4980A-11

S E R V I C E N O T E

HP 4980A Network Advisor

Monochrome LED Board Modification (NOT Color)

J2176-66502 LED Board Assembly

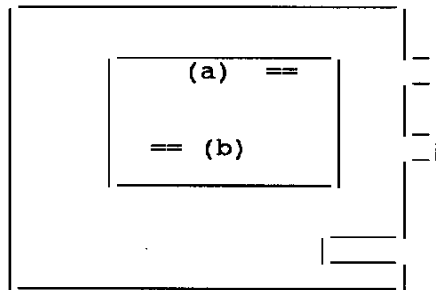
When new monochrome assembly 5063-1880 is required to replace the older 5062-9677 display, the LED board must be modified. The modification will allow a greater range of brightness adjustment.

1. Remove fastener(s)
2. Disconnect jumper wires

3. Carefully snap out LED display board assembly
4. Locate jumper and remove at one of either location as shown in the diagram

Jumper locations
(a) or (b) is on
the small board.

5. Reinstall wires/fasteners and board assembly
6. Test brightness operation
